Plastic tanks

In our ongoing commitment to improving product quality, we are pleased to inform you that our 30L and 46L plastic oil tanks have been updated with new features.

V1PL2N03041 - 30 lt

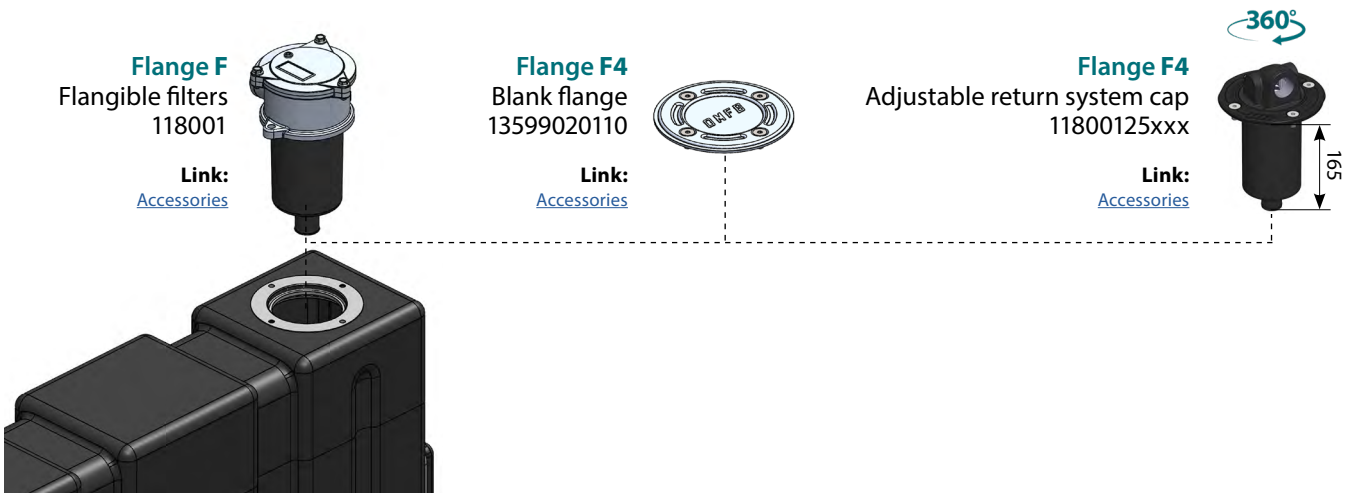
Replace the V1PL2N03040

WAS	BECOMES
 <p>oil level</p>	 <p>oil level indicator temperature</p>
 <p>$\phi 90$ 115 2 screws M8</p>	 <p>$\phi 80$ 115 4 threaded holes</p>
